PRODUCT/PROCESS CHANGE NOTIFICATION

PCN APG/13/7949
Dated 19 Jun 2013

STANDARDIZATION OF SECOND BOND TIP DESIGN FOR POWERSO20 LEADFRAME

LEAD TIP REDESIGN FROM SQUARE TO SHAPED PATTERN

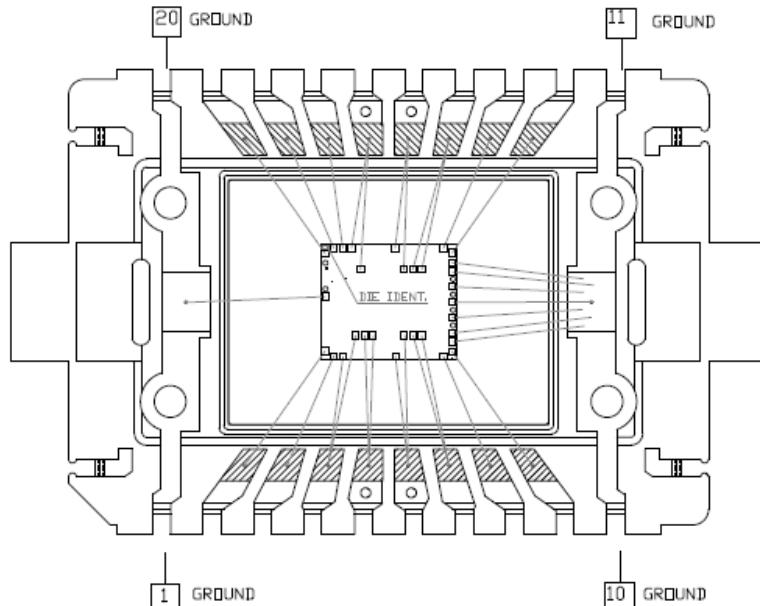
Following copper wires introduction on PowerSO20 matrix line, we are going to standardize the leadframe options by adopting the most recent solution for second bond tip design.

Apart from lead tip design change, assy materials, plating and design details of the leadframe are unchanged. For this reason only the thermo-mechanical aspects have been considered in the reliability exercise.

Current Leadframe

New Leadframe
